Project	IEEE 802.16 Broadband Wireless Access Working Group < http://ieee802.org/16 >	
Title	Fast-feedback channel enhancement in OFDMA	
Date Submitted	2005-03-09	
Source(s)	Bin-Chul Ihm, Yongseok Jin, Jinyoung Chun LG Electronics, Inc.	Voice: 82-31-450-7187 Fax: 82-31-450-7912 [mailto: {bcihm, jayjay, jychn03}@lge.com]
Re:	This is a response to a Call for Comments on IEEE P802.16e-D6	
Abstract	Pilot carriers can be used as secondary CQICH in OFDMA	
Purpose	This document is submitted for review by 802.16e Working Group members	
Notice	This document has been prepared to assist IEEE 802.16. It is offered as a basis for discussion and is not binding on the contributing individual(s) or organization(s). The material in this document is subject to change in form and content after further study. The contributor(s) reserve(s) the right to add, amend or withdraw material contained herein.	
Release	The contributor grants a free, irrevocable license to the IEEE to incorporate material contained in this contribution, and any modifications thereof, in the creation of an IEEE Standards publication; to copyright in the IEEE's name any IEEE Standards publication even though it may include portion

Figure 231f—Subcarrier mapping of primary Fast-feedback modulation symbol for PUSC

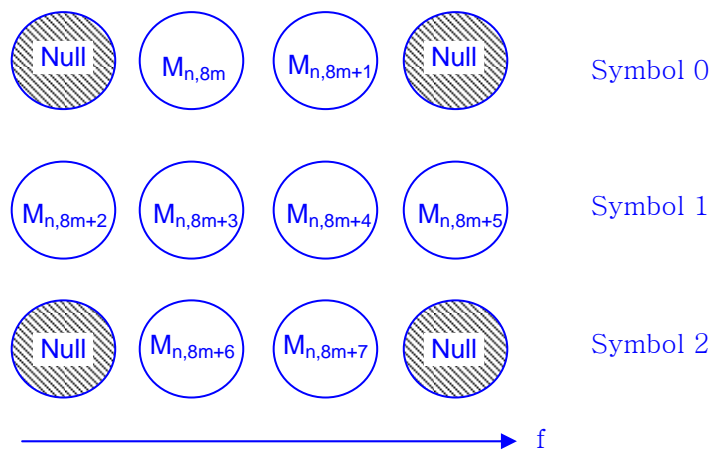
Primary Fast-feedback slot consists of 1 OFDMA slots mapped in a manner similar to the mapping of normal uplink data. A primary Fast-feedback slot uses QPSK modulation on the 48 data sub-carriers of UL PUSC tiles it contains, and can carry a data payload of 6 bits. The primary Fast-feedback slot has identical mapping between the payload bit sequences and the subcarriers modulation as the enhanced Fast-feedback slot of payload 6 bit except null pilot subcarriers within the slot.

Figure 231g —Subcarrier mapping of secondary Fast-feedback modulation symbols for PUSC

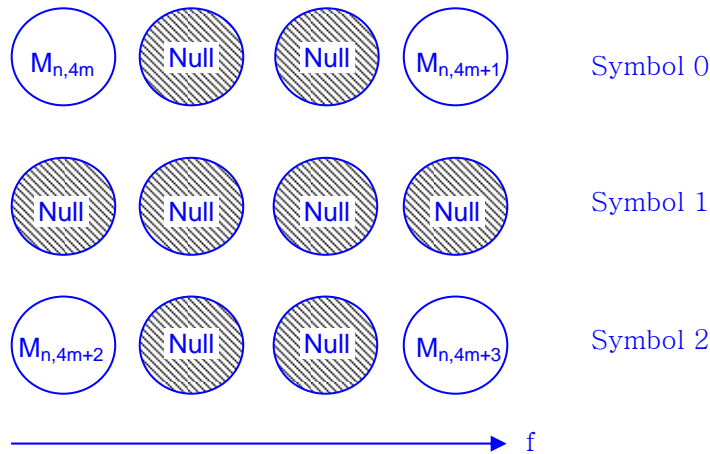
Secondary Fast-feedback slot consists of 1 OFDMA slots mapped in a manner similar to the mapping of normal uplink data. A secondary Fast-feedback slot uses QPSK modulation on the 24 pilot sub-carriers of UL PUSC tiles it contains, and can carry a data payload of 4 bits. Table xxx defines the mapping between the payload bit sequences and the subcarriers modulation.

$M_{n,4m+k}$ are mapped to secondary Fast-feedback channel tile as shown in Figure 231g for PUSC uplink subchannel. A secondary Fast-feedback channel is mapped to one subchannel composed of 6 tiles.
